STRUCTURAL ADDENDUM-No: SA-01

Re: 321 John Street, Cobourg, ON
Clarifications & Updates to Structural Documents

The following items are changes to project Contract Structural Documents. General Contractors shall include the items described in their tender bid including all labour, material, equipment and services required to complete the work described.

S501

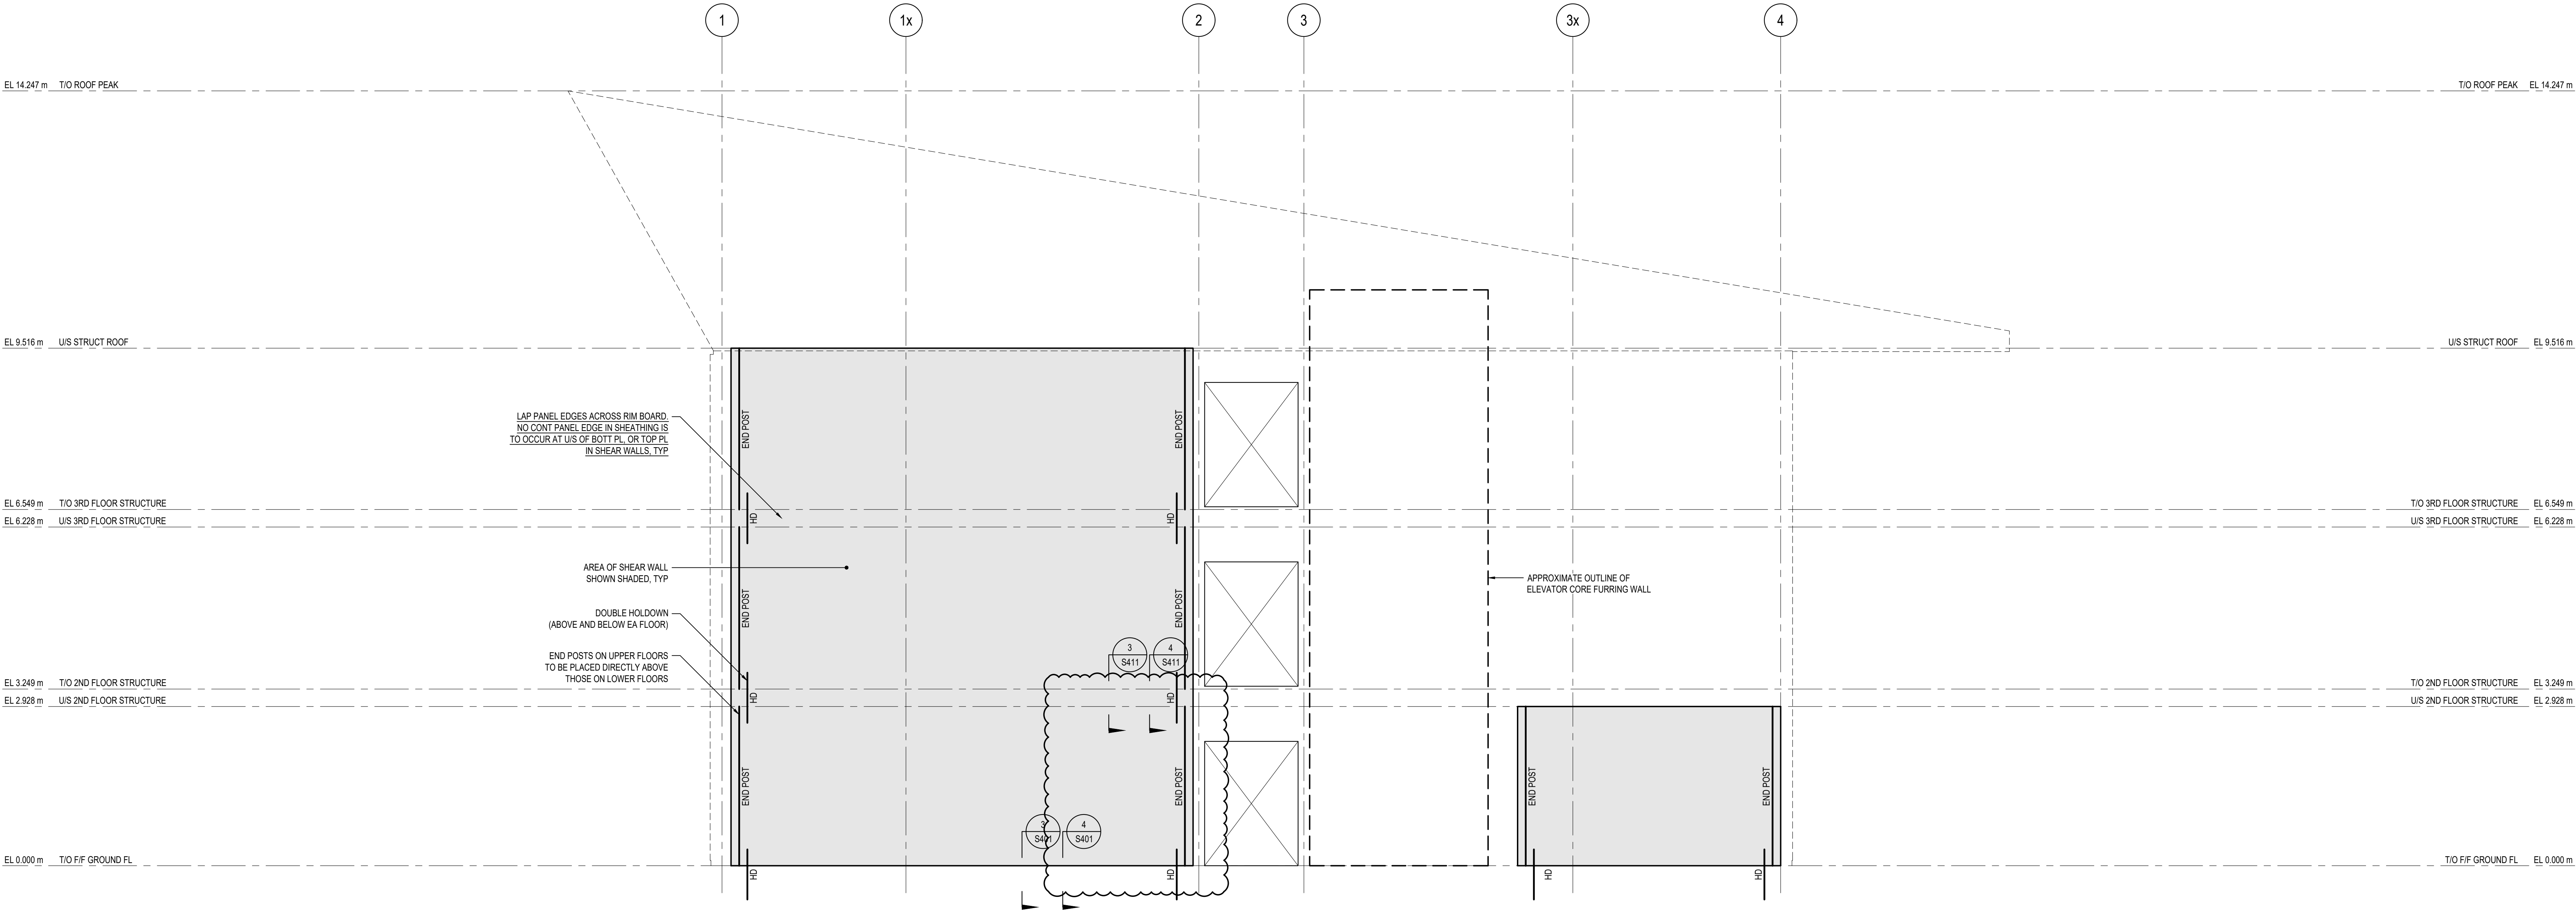
12.0 S501 Shear Wall Elevations

12.1 Visual adjustment made to openings by request from architect.

S502

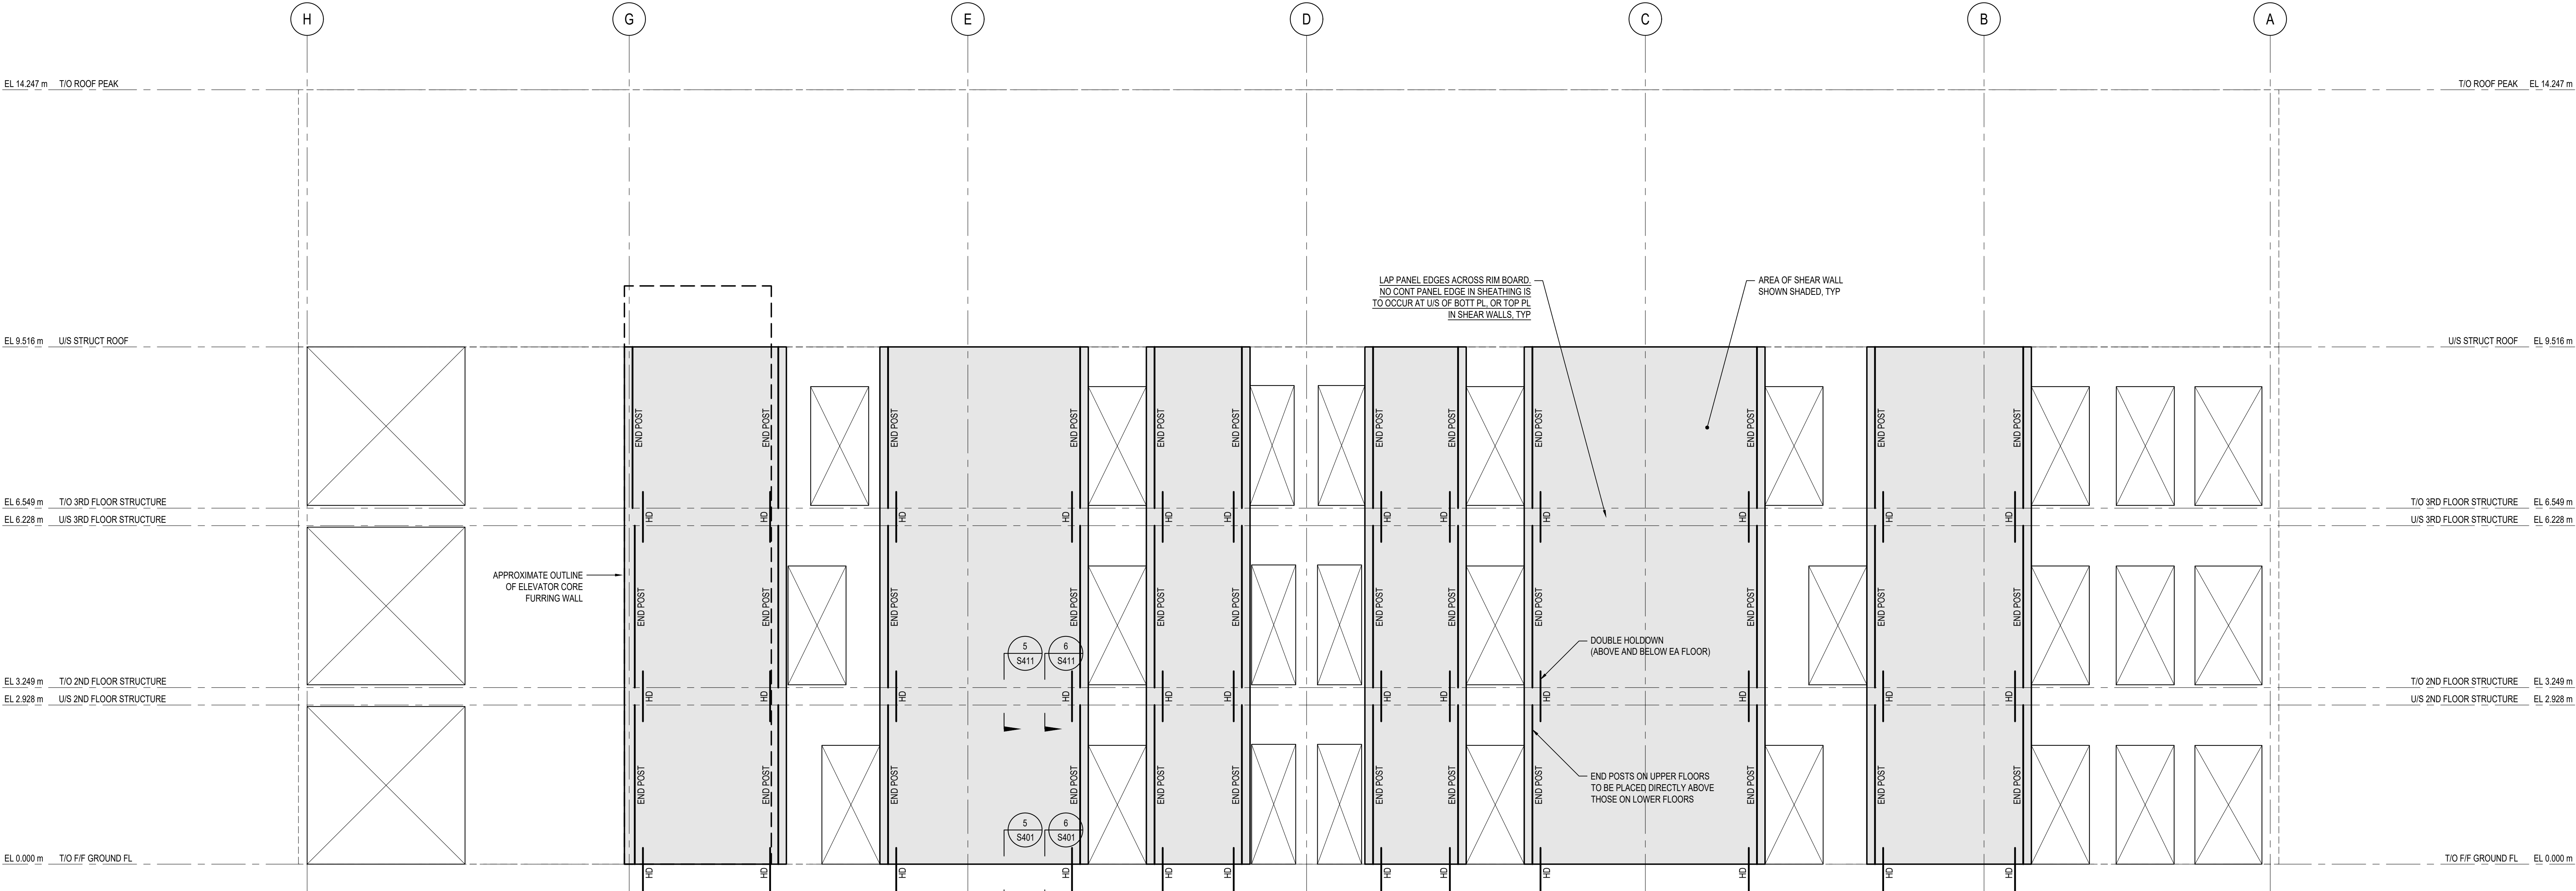
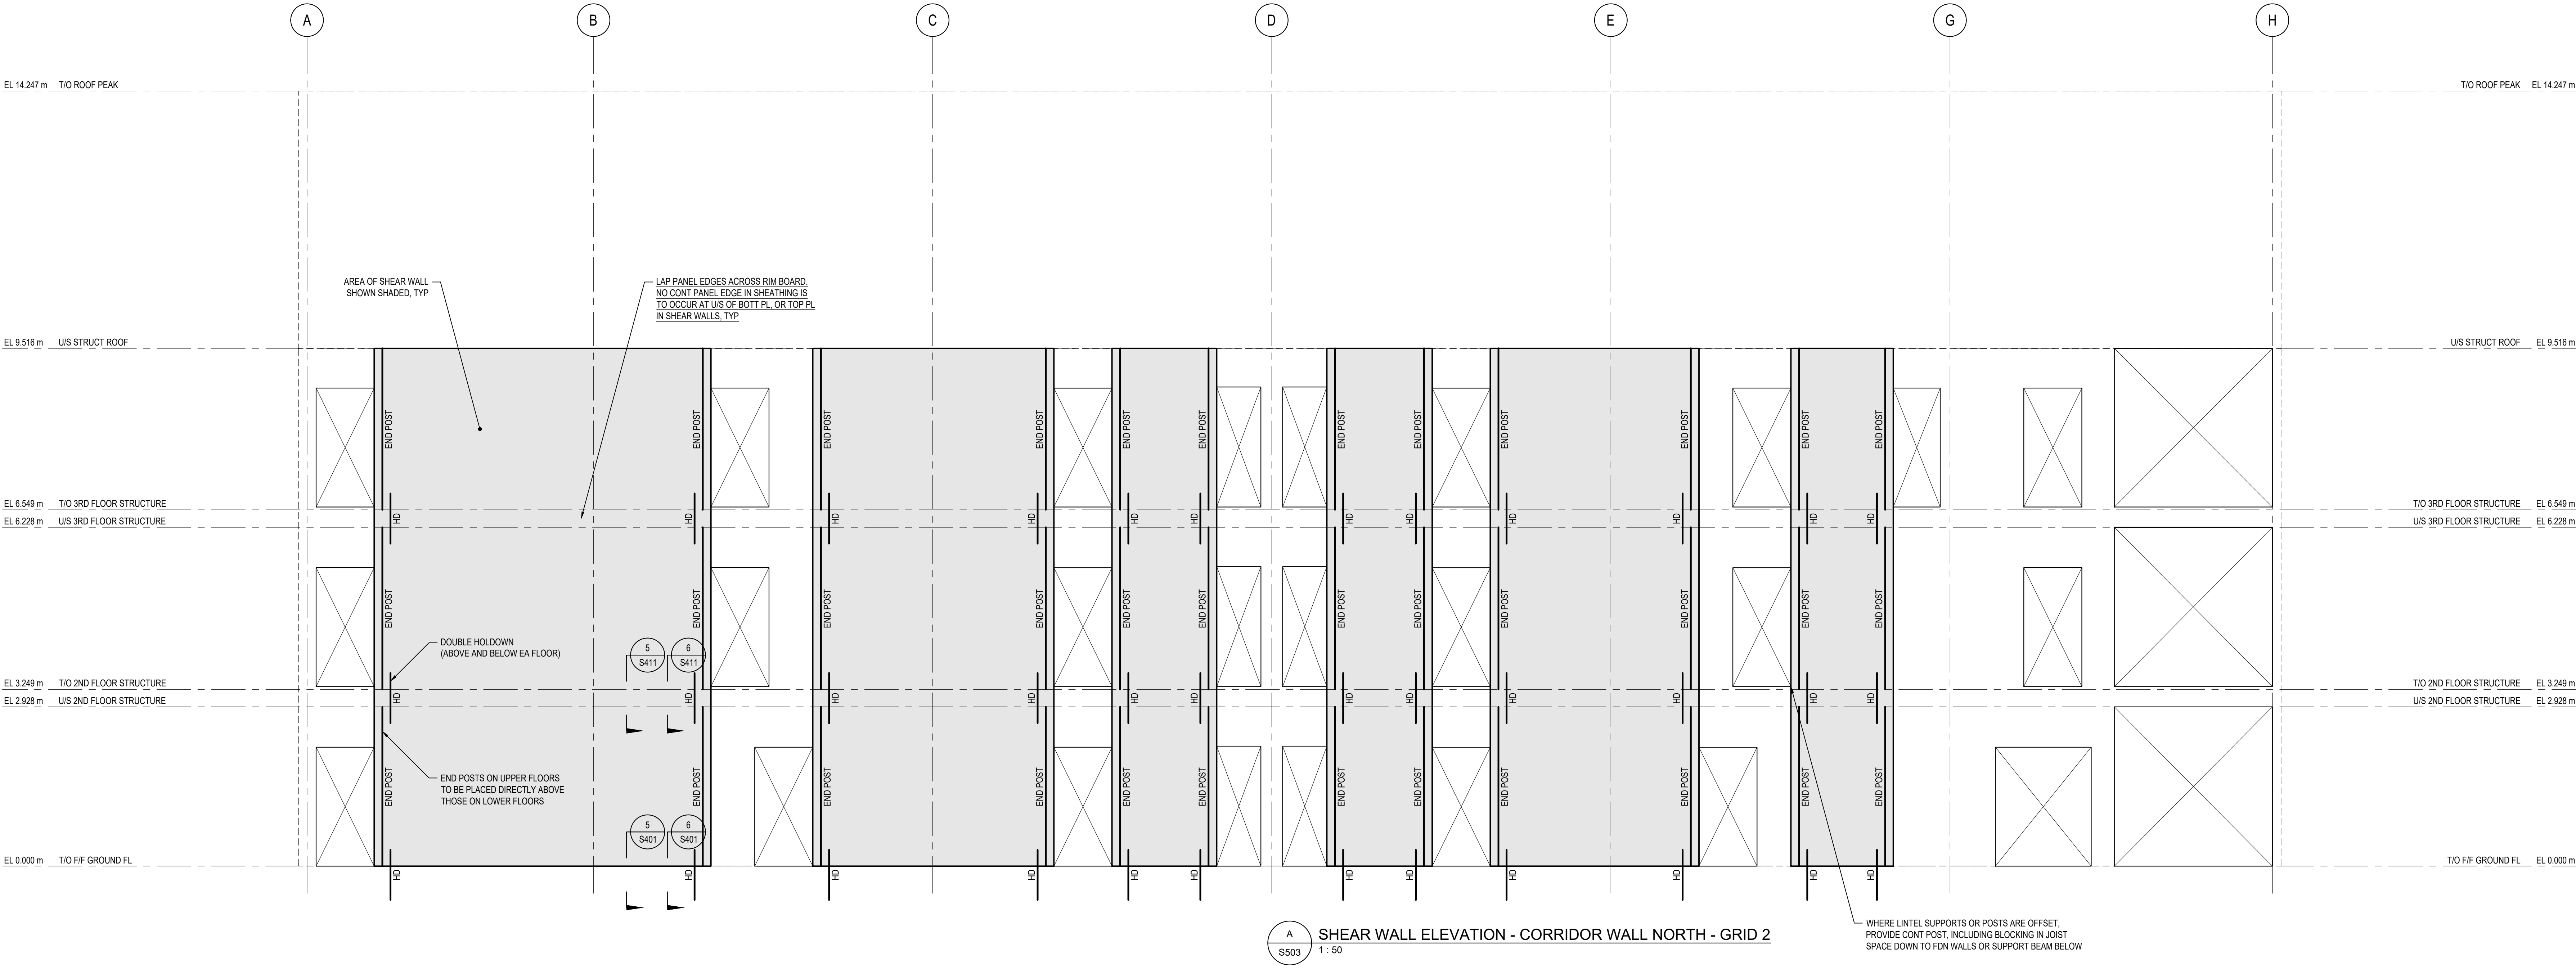
13.0 S502 Shear Wall Elevations

13.1 Opening in first floor wall removed in A/S502. Extent of shear wall increased.
